Item Name: Crosstube Assembly, Mid Fwd

DART AEROSPACE LTD	Work Order:	108681
Description: Crosstube Assembly, Mid Fwd	Part Number:	D206-667-147
Inspection Dwg: D206-667-147 Rev: A		Page 1 of 2

DART AEROSPACE LTD HAWKESBURY, ONTARIO, CANADA	
DRAWING NO. D206-667-147	REV. A SHEET 1 OF 4
TITLE CROSSTUBE ASS'Y (206L MID FWD)	SCALE NTS
COPYRIGHT © 2010 BY DART AEROSPACE LTD THIS DOCUMENT IS PRIVATE AND CONFIDENTIAL AND IS SUPPLIED ON THE EXPRESS CONDITION THAT IT IS NOT TO BE USED FOR ANY PURPOSE OR COMING OR COMMUNICATED TO ANY OTHER PERSON WITHOUT WRITTEN PERMISSION FROM DART AEROSPACE LTD.

DRAWING NO. D206-667-147	TITLE CROSSTUBE ASS'Y (206L MID FWD)	REV. A	DART AEROSPACE LTD ENGINEERING ORDER		D.E.O. NO. D206-667-147-A-1	SHEET NO. SHEET 1 OF 1	SCALE NTS
DRAWN 92	CHECKED ADS	MFG. APPR. PB	APPROVED MD		DE APPR. H		
DATE 11.07.15	DATE 11.07.20	DATE 11.07.21	DATE 11.07.21		DATE 11.07.21

DETAIL P
BONDING STRAP INSTALLATION 2 PL

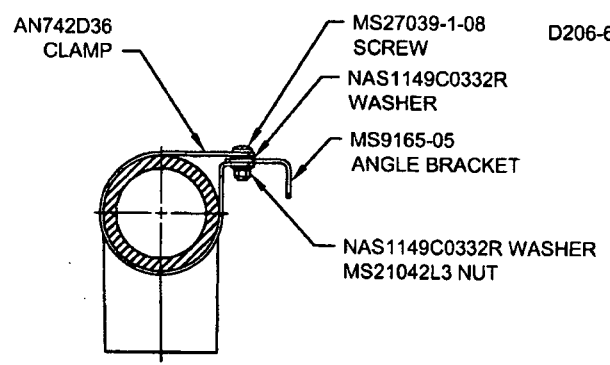
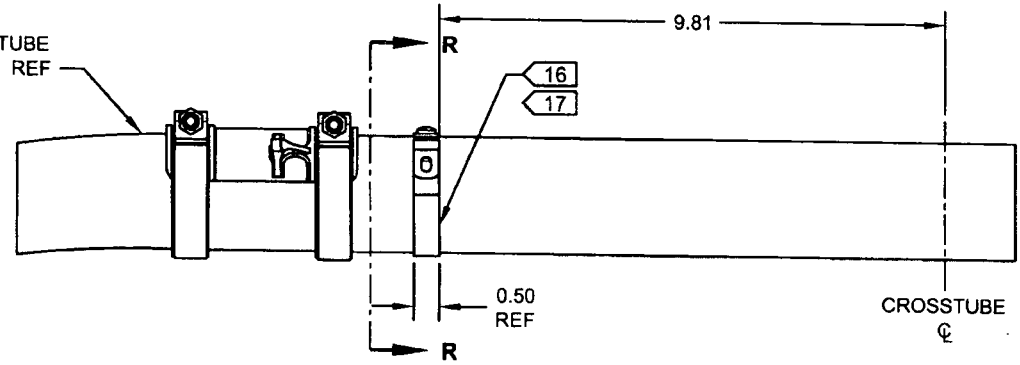
ADD ELECTRICAL GROUNDING STRAP

ITEM	QTY -147	PART NUMBER	DESCRIPTION
1	X	D206-667-147	CROSSTUBE ASSEMBLY (206L MID FWD)
⚡			
10	2	AN742D36	CLAMP
11	2	MS9165-05	ANGLE BRACKET
12	2	MS21042L3	NUT (OR MS21042-3)
13	2	MS27039-1-08	SCREW
14	4	NAS1149C0332R	WASHER (OR AN960C10L)

- 16) MASK AREA UNDER CLAMP PRIOR TO PAINTING
- 17) SEAL EDGES WHERE AN742D36 CLAMP MEETS WITH THE CROSSTUBE USING SIKAFLEX-241/-291 OR MIL-S-8802 CLASS B2 OR PROSEAL 890 SEALANT
- 18) PERFORM RESISTANCE CHECK TO ENSURE MAX RESISTANCE IS 10 MILLIOHMS
